# MEADOWBANK IN-PIT DISPOSAL MEETING ECCC/AGNICO EAGLE

JULY 12<sup>TH</sup>, 2018

# MEETING AGENDA

Figure 4 Run 4 – Fine Silt with 2.75 m water cover and expected wind velocity

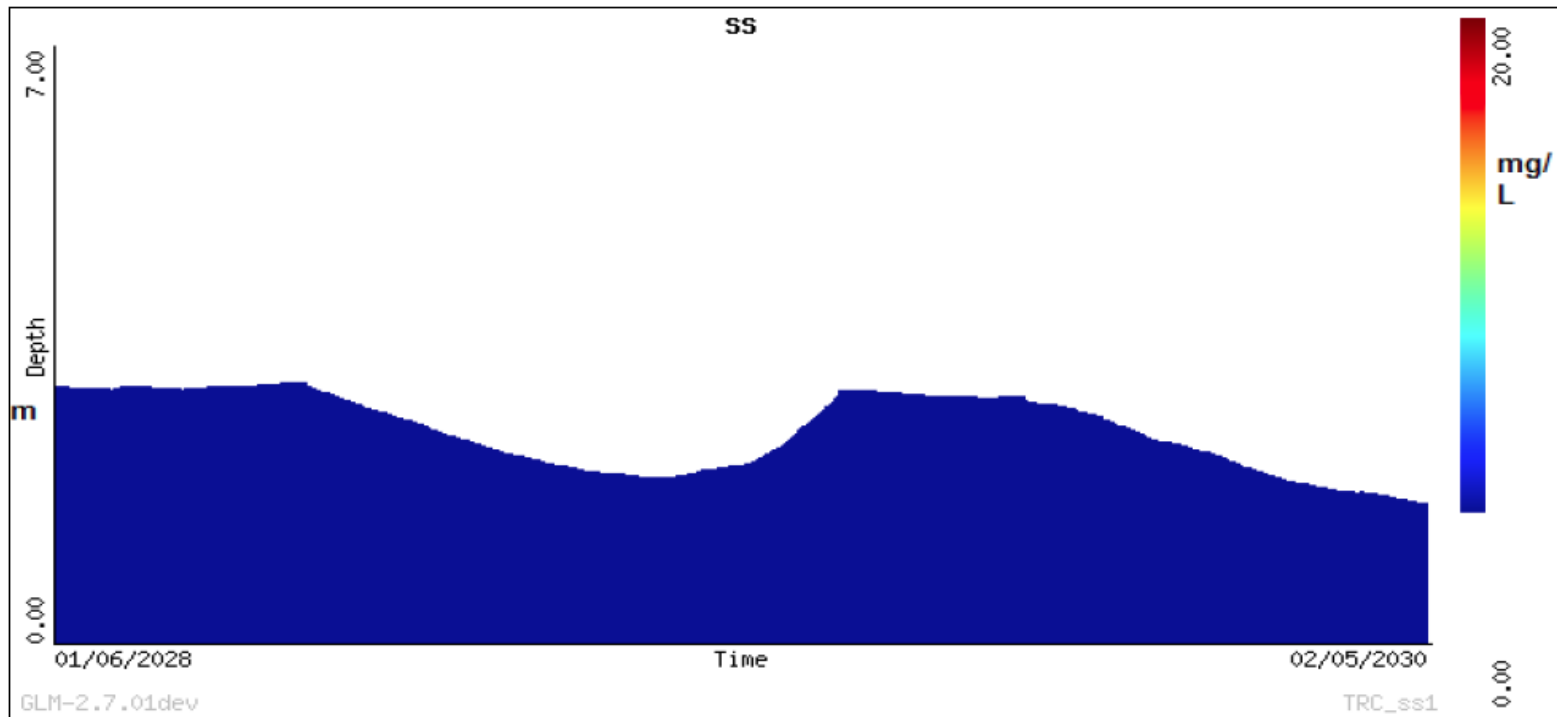
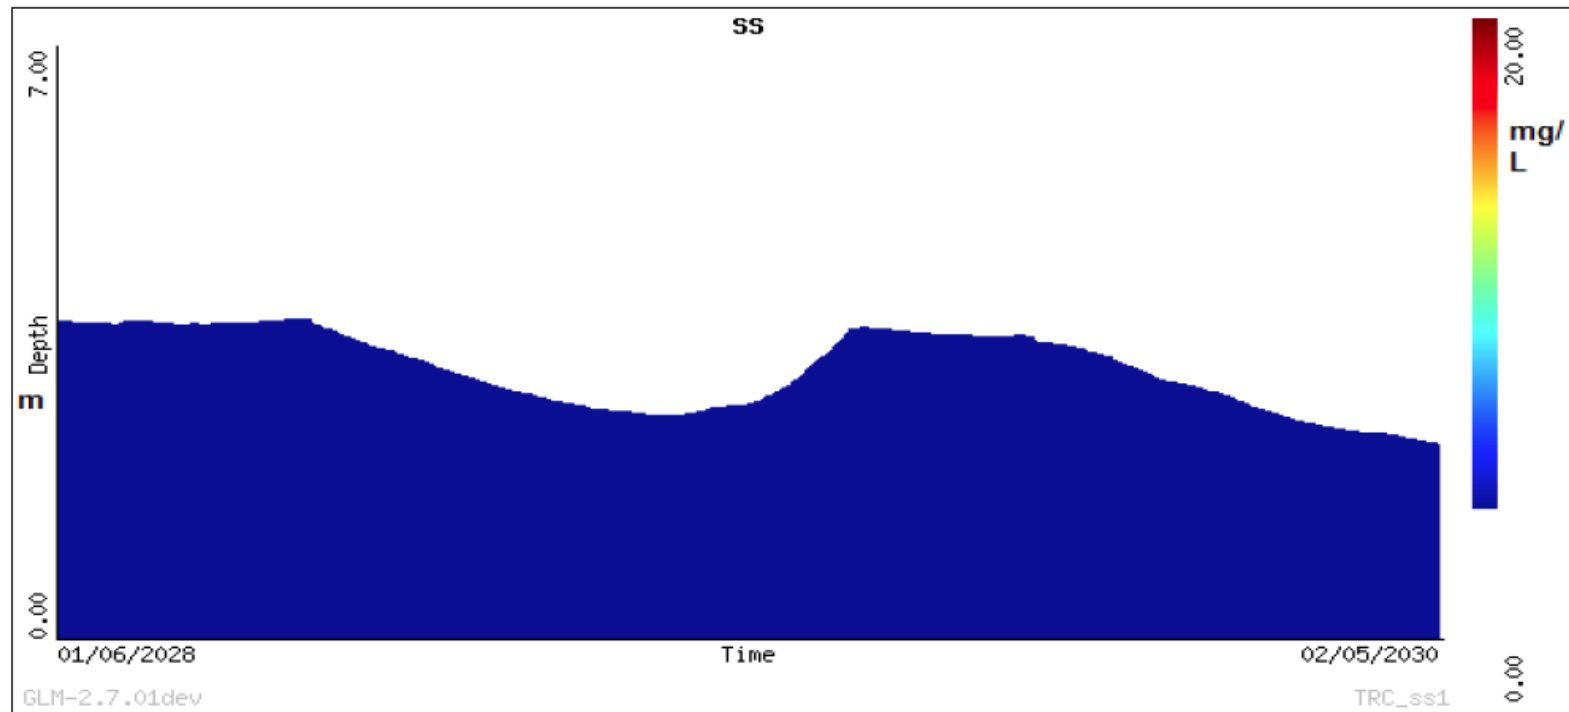
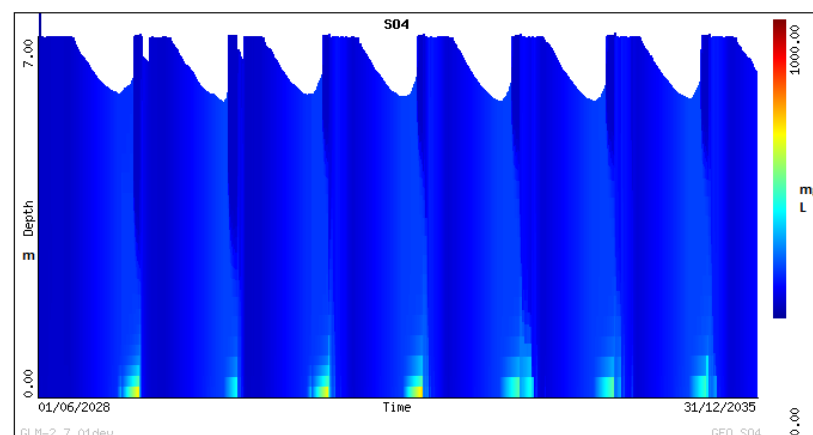
- a) *ECCC requests that the Proponent provide a rationale for the 8 m water cover depth.*
- b) *ECCC requests that the Proponent clarify if monitoring of the pore water quality will be conducted.*
- c) *ECCC requests that the Proponent discuss potential effects of the tailings on water quality, and identify measures to mitigate effects to water quality.*

➔ Negligible re-suspension at a depth of 2.75 m water cover for expected wind velocity

- During the conceptual engineering phase, the minimal 8 meters water thickness cover was selected in order to keep any tailings inside the pit and avoid having any tailings covering the 2<sup>nd</sup> and 3<sup>rd</sup> Portage lake bed sediments exposed around the pits following the Meadowbank dewatering phase. During the pre-feasibility engineering phase, SNC-Lavalin completed the assessment of the minimum 8 metre water cover and confirmed that it will provide a very high safety factor in the prevention of tailings re-suspension. Furthermore, during the operation of the in-pit tailings pond, the tailings beach will have a slope varying between 2 to 5% based on Meadowbank operational experience. It is expected that the water cover thickness along the tailings will be variable. Minimum water cover thickness of 8 metres will be observed at the deposition point and water thickness will increase as tailings beach formation progress through the tailings pond.

- The rationale for the 8 m water cover depth was based upon the following:
- The proposed 8 metre minimum thickness of water cover above the tailings interface will result in negligible oxidation of the sulphide content of tailings materials (as noted previously several times greater than the fore mentioned referenced sites (SNC 2018b)) where a water cover has reported negligible rates of sulphide oxidation; and

- An assessment of the potential for tailings re-suspension (SNC-Lavalin 2018b) was presented by Agnico Eagle in the response of the IR-ECCC- 1-b.

## Monitoring Wells Network Expansion

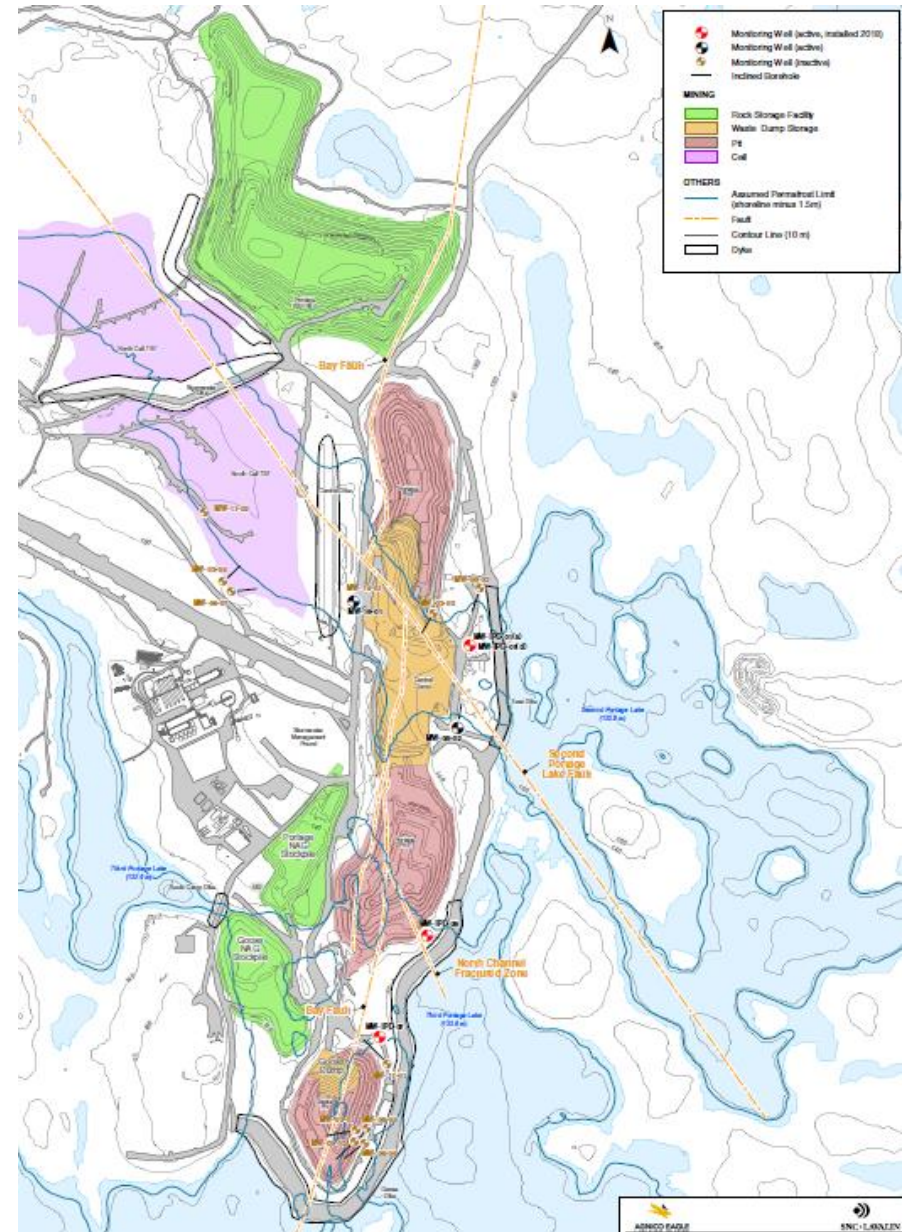
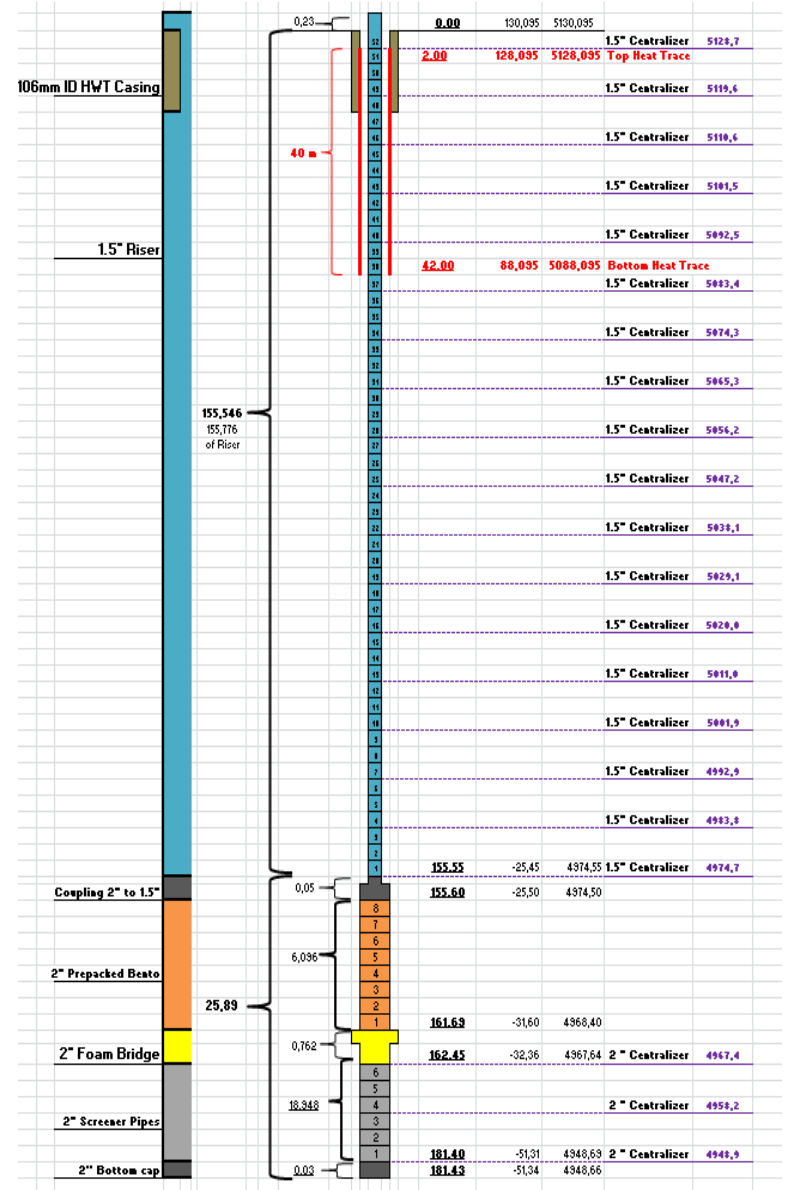
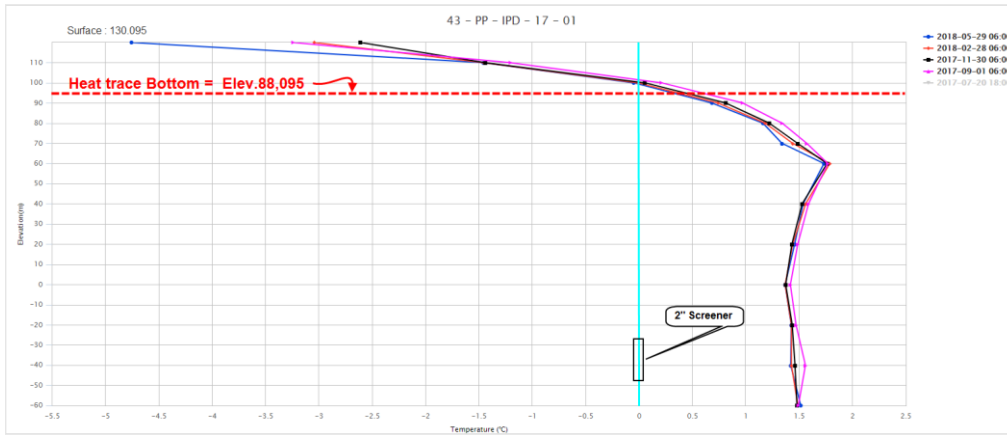
*a) ECCC requests that the Proponent identify the depth that groundwater wells will be sampled.*

*b) ECCC requests that the Proponent discuss monitoring and mitigation/contingencies for addressing potential contaminant migration out from the pits into groundwater. Response guideline: briefly explain how treatment of the contaminant source mitigate the contamination migration*

## ➡ Install monitoring Wells (MW) network

- Add 4 deep MW (60 to 180 mbgs) at key location
- Talik area between pits and lakes are targeted

Depth of the six (6) actual groundwater monitoring wells varies from 50 to 180 m. Specifically, monitoring wells depth are: 50 m (MW-IPD-07), 70 m (MW-IPD-01s), 80 m (MW-IPD-09), 101 m (MW-16-01), 150 m (MW-08-02) and 180 m (MW-IPD-01d).

- The groundwater monitoring network has been expanded in 2018 with the addition of four (4) new monitoring wells, adapted to the in-pit tailing deposition project. The 3D hydrogeological model was used to locate each new monitoring wells in the predicted groundwater flow paths in talik areas from the pits to the lakes. Monitoring wells will maintain their integrity over time in talik environment. Prior well installation, a hydrogeological and thermal field investigation was carried out to adapt the installation to each local condition and to target the most fractured zones at pit depths.
